WALKER
MANUFACTURING CO.

ADVISORY BULLETIN # 16254

SUBJECT: Deck Support Arm Change

MODELS AFFECTED: All MH24d, MH25, and MH27i Models Prior to S/N 16-139211

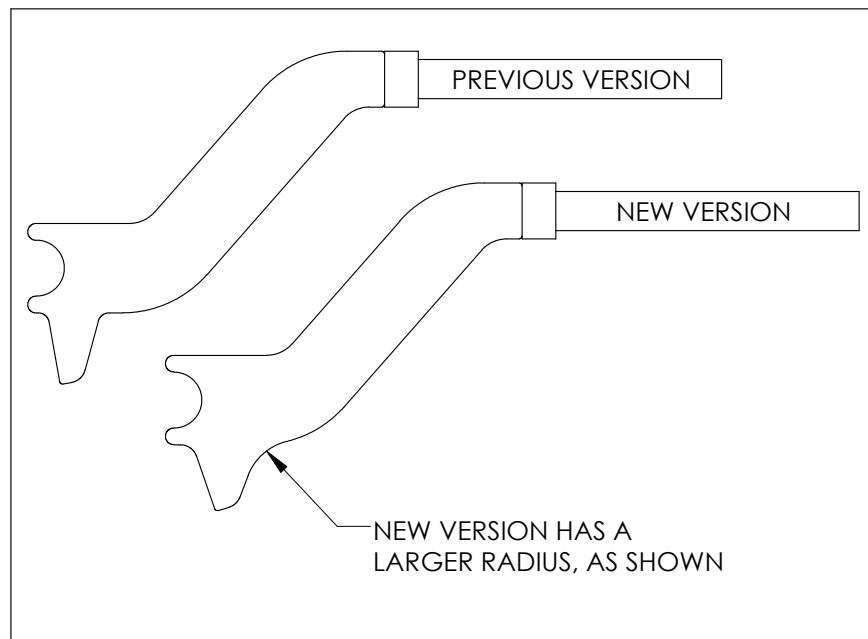
PURPOSE: Walker has found the rear dolly wheels of the DR64 are lifting off the ground when the deck is in the tilt-up position, which is transferring additional weight to the deck support arms. The deck support arms have been redesigned to increase travel, enabling the rear dolly wheels to support the weight of the deck when in the tilt-up position. The new deck support arms (RH P/N 2430-2, LH P/N 2431-2) supersede the original design (RH P/N 2430, LH P/N 2431) and can be used as a replacement part on all earlier MH tractors; It is recommended to change **both arms** as a pair.

Order one (1) 2430-2 Deck Support Arm RH and one (1) 2431-2 Deck Support Arm LH.
